## Product Change Notification

1. ECR #: 26-51347-1  
Notification #: 831

- COM-HPC WT - null

OLD ASP-230387-01-B (Male 1.5)

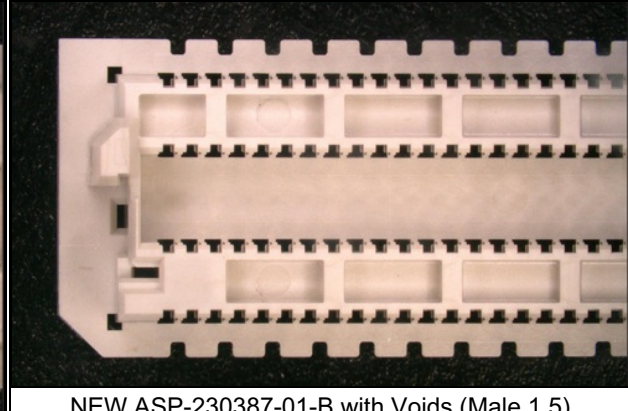
Form change, voids were added to the Male body, and a new material is used for the male and female to allow processing without a weight. Old revision material will no longer be used on the male and female. This will be a hard cut implementation.

The new material color is still a NATURAL white color, but it has a different tint. The male body has additional voiding on the top of the part.
